**Economic Commission for Europe****Inland Transport Committee****World Forum for Harmonization of Vehicle Regulations****Working Party on Passive Safety****Fifty-ninth session**

**Regulation No. 16 (Safety-belts)****Proposal for the 07 series of amendments to Regulation  
No. 16 (Safety-belts)****Submitted by the experts from France Japan, Republic of Korea and  
European Commission\***

## "Annex 2

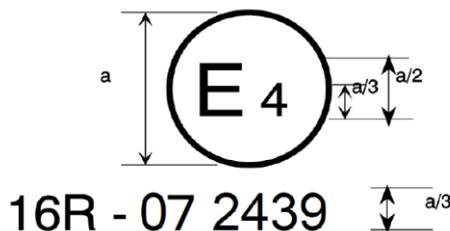
Annex 2, amend to read:

The above approval mark affixed to a vehicle shows that the vehicle type concerned has, with regard to safety-belts, been approved in the Netherlands (E 4) pursuant to Regulation No. 16. The approval number indicates that the approval was granted according to the requirements of Regulation No. 16 as amended by the 07 series of amendments.
